**A/YL-KTN/1174 – Address DSD's comments**

**Temporary Shop and Services for a Period of 5 Years,  
Lot 283 S.A RP (Part) in D.D. 109, Kam Tin, Yuen Long,  
New Territories**

## **Drainage Proposal**

**FIGURE NUMBER**  
**FIGURE 3**

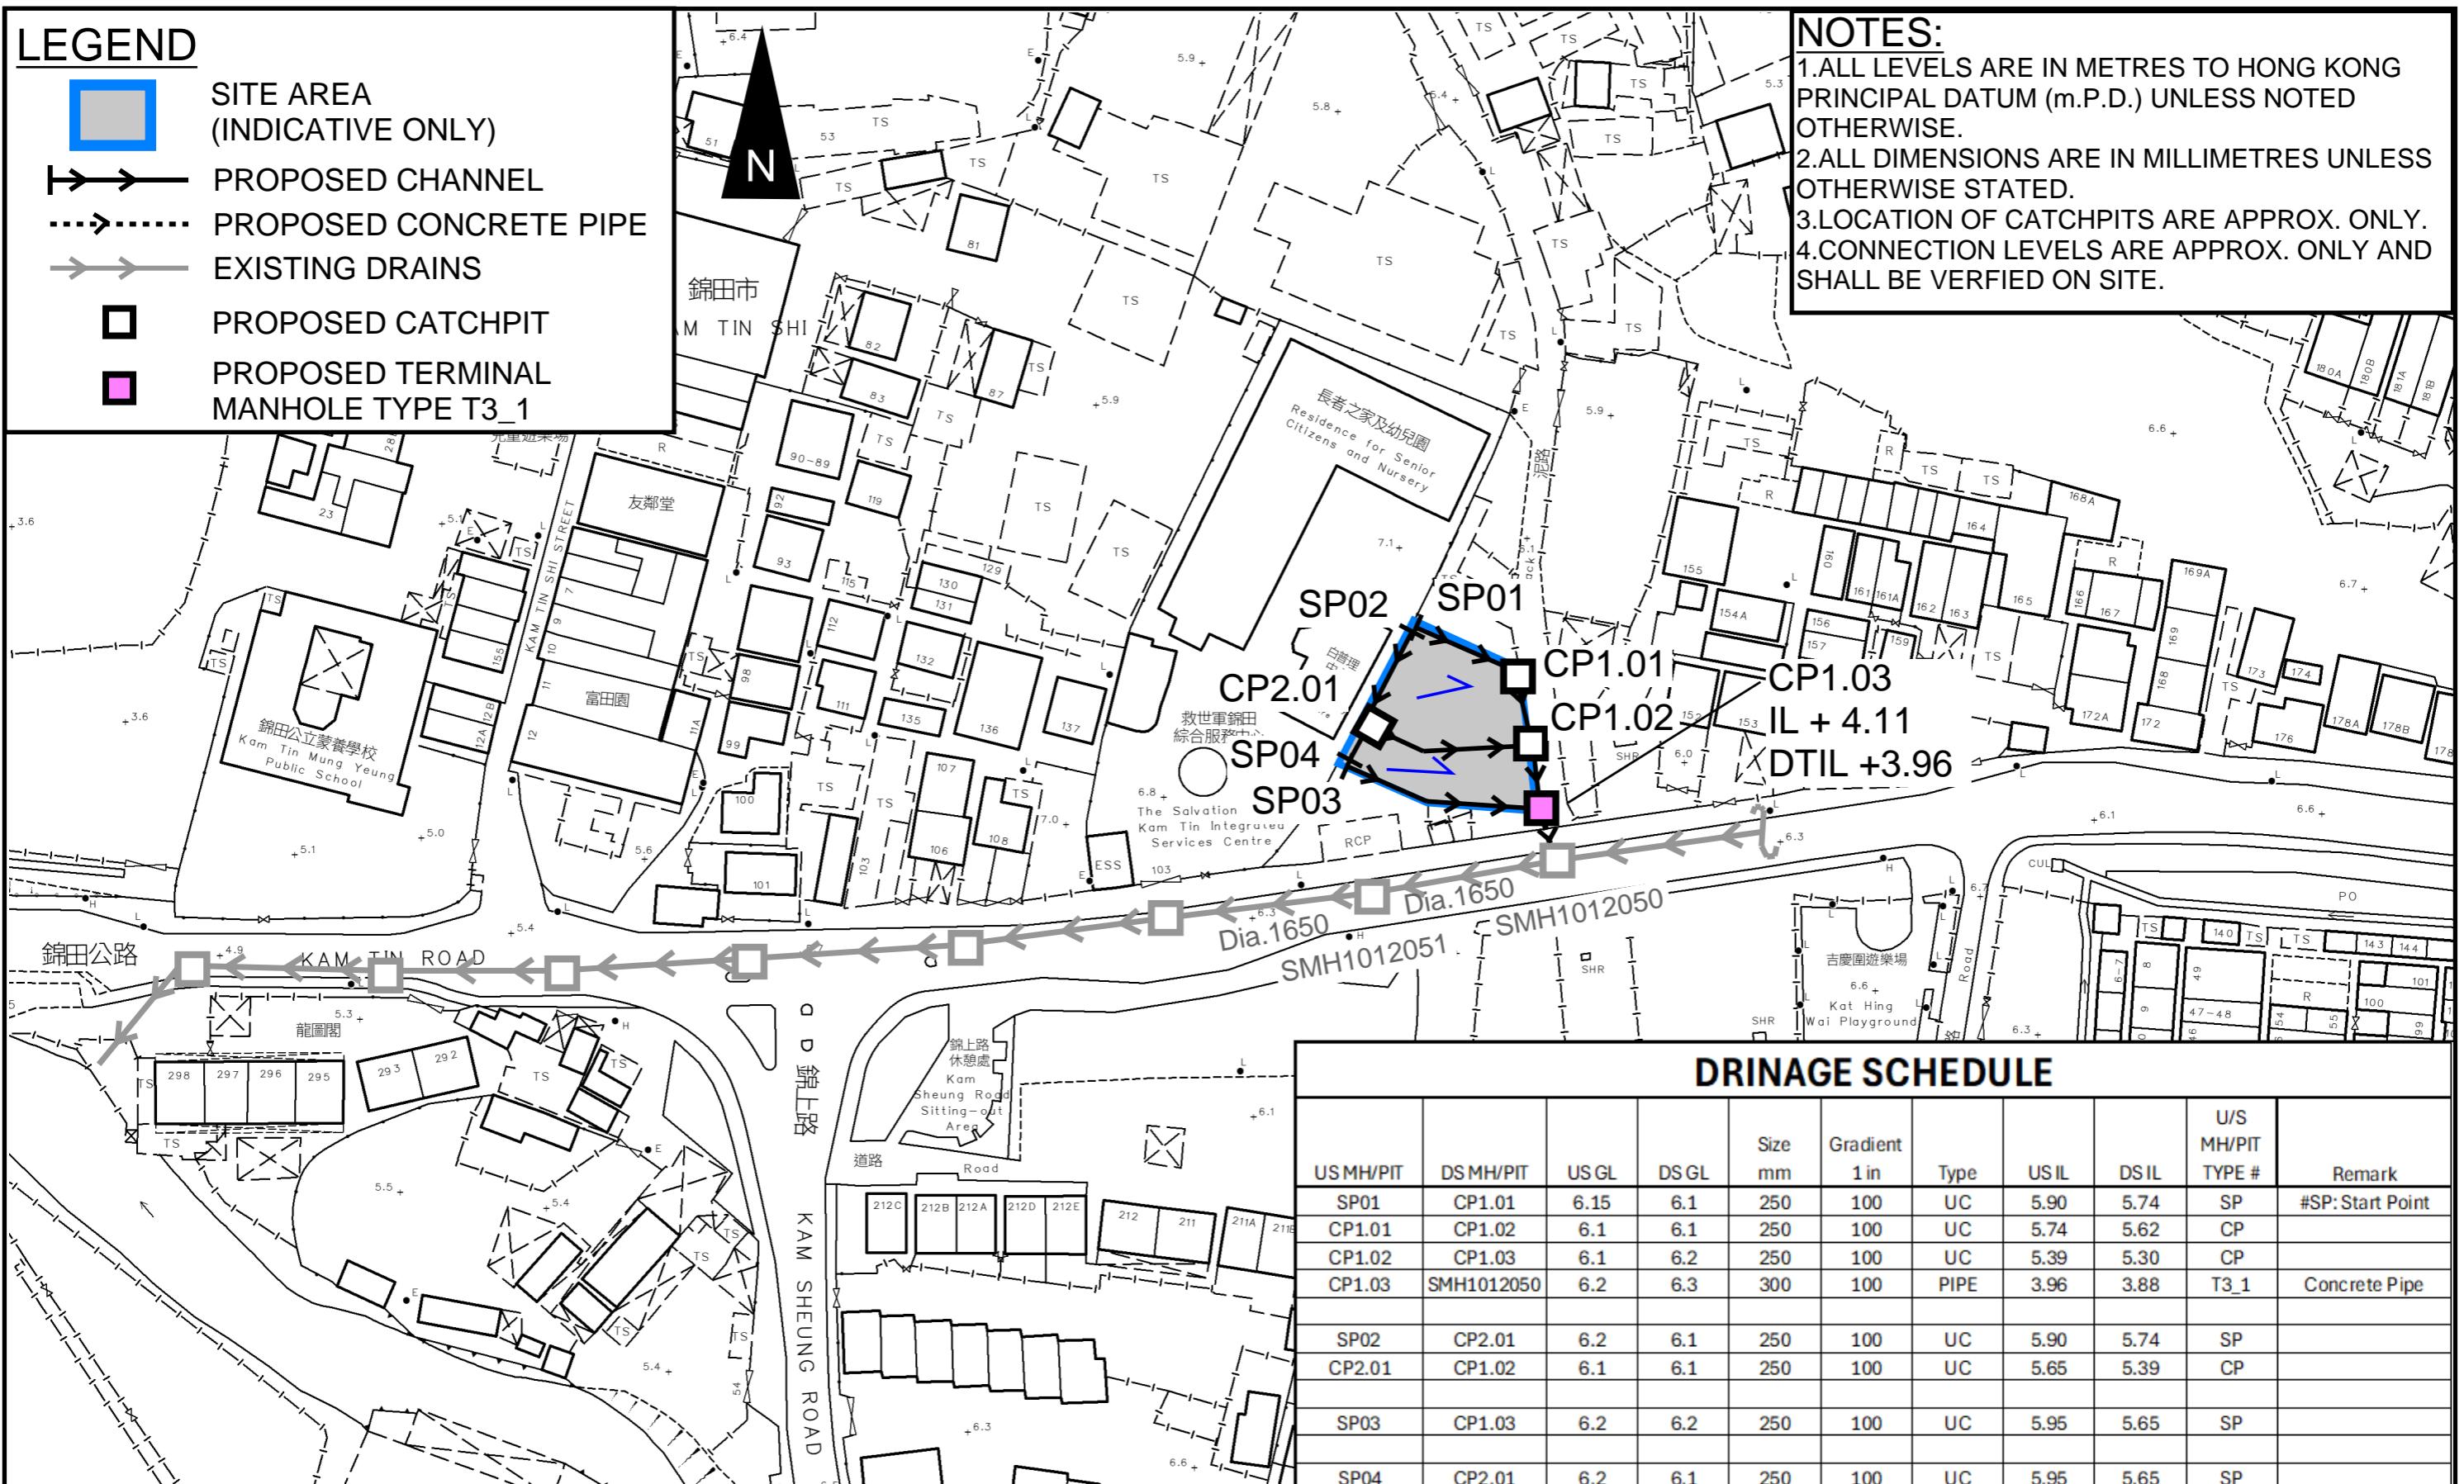
| <b>Item</b> | <b>Comments</b>  | <b>Responses</b>   |
|-------------|--|--|
| 4           | Peripheral surface channels shall be provided along the site boundary to collect the surface runoff accrued on the application site and to intercept the overland flow from the adjacent lands.  | Noted. Updated drainage plan in Figure 3 with surface channel along site boundary for your perusal.  |

| 19 | The applicant should clarify manhole ID in the submitted hydraulic calculation (ref. LOT283/GL/001).  | Manhole ID are shown in updated Figure 3 for your perusal.   |

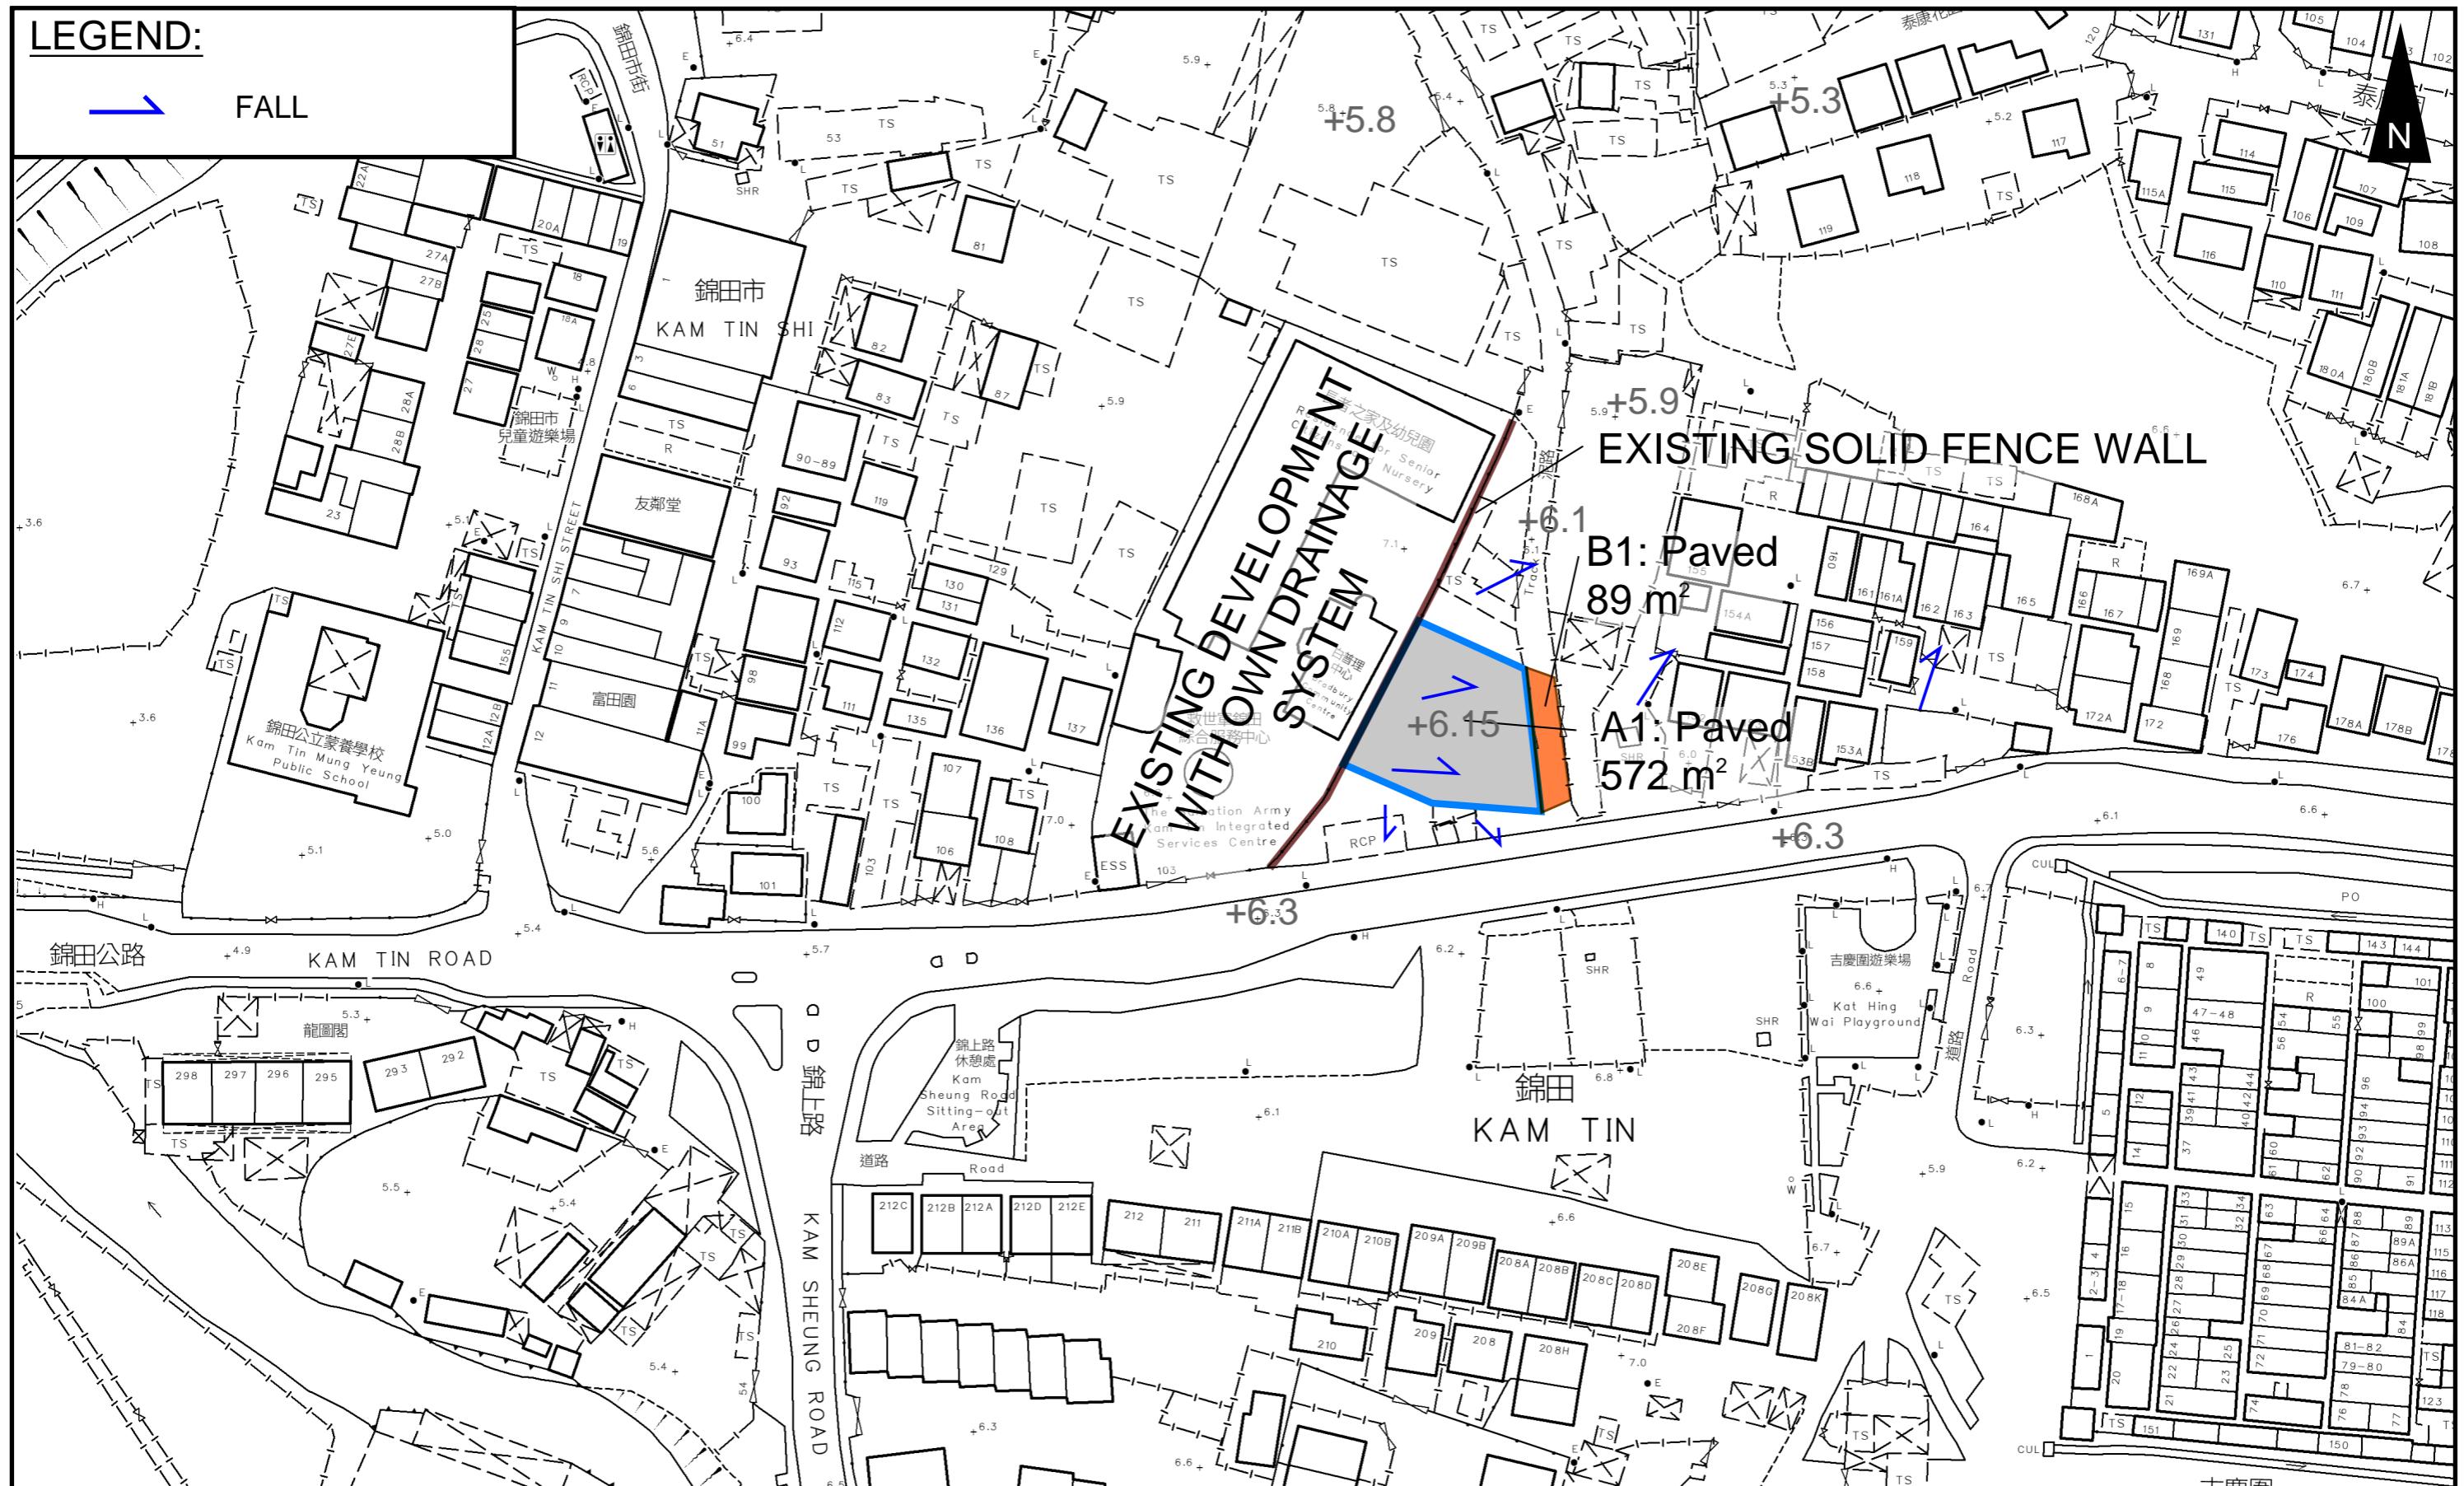
| <b>Item</b> | <b>Comments</b>  | <b>Responses</b>   |
|-------------|--|--|
| 1           | The ground to the west of the application site is generally higher. Since the overland flow from the adjacent lands shall be probably intercepted, external catchment shall be considered in the calculation. According to the topography around the subject site, the catchment area shall be greater than the one adopted in the submitted hydraulic calculation. The applicant should update hydraulic calculation. | <p>Please kindly note the development at west of the application site is fenced off by its own solid fence wall. Photos of existing wall are shown in Appendix D for your perusal.</p> <p>The drainage report is updated. An updated calculation with external catchment and catchment plan are updated in Appendix A and Figure 4 for your perusal.</p> |
| 3           | The proposal should indicate how the runoff (the flow direction) within the site and from the adjacent areas would be discharged to the proposed drainage system.  | Catchment plan with flow direction is updated in Figure 4 for your perusal.  |

FIGURE NUMBER  
FIGURE 5

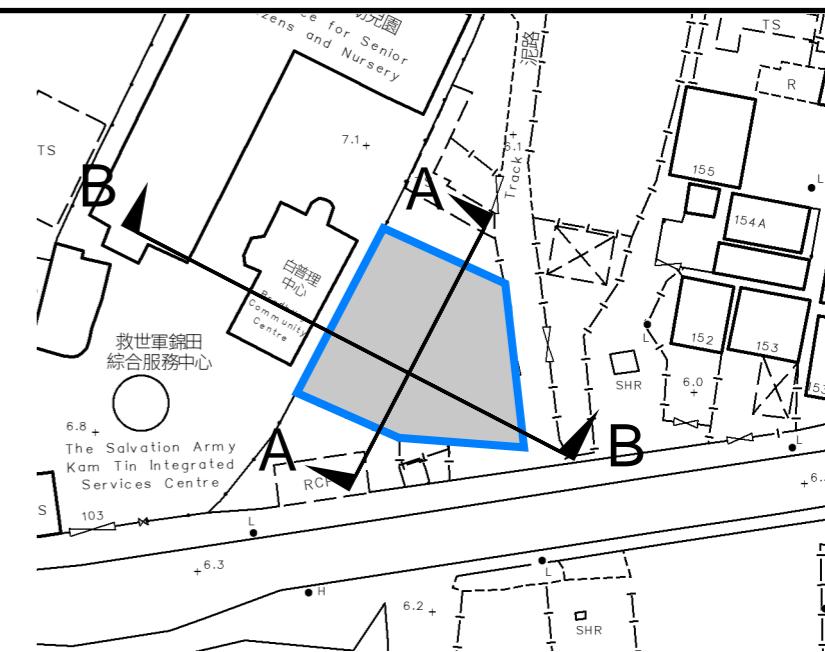
| <b>Item</b> | <b>Comments</b>  | <b>Responses</b>   |
|-------------|--|--|
| 2           | Cross sections showing the proposed drainage facilities and existing and proposed ground levels of the captioned site with respect to the adjacent areas should be given.  | Noted. Please find Figure 5 for your perusal.  |
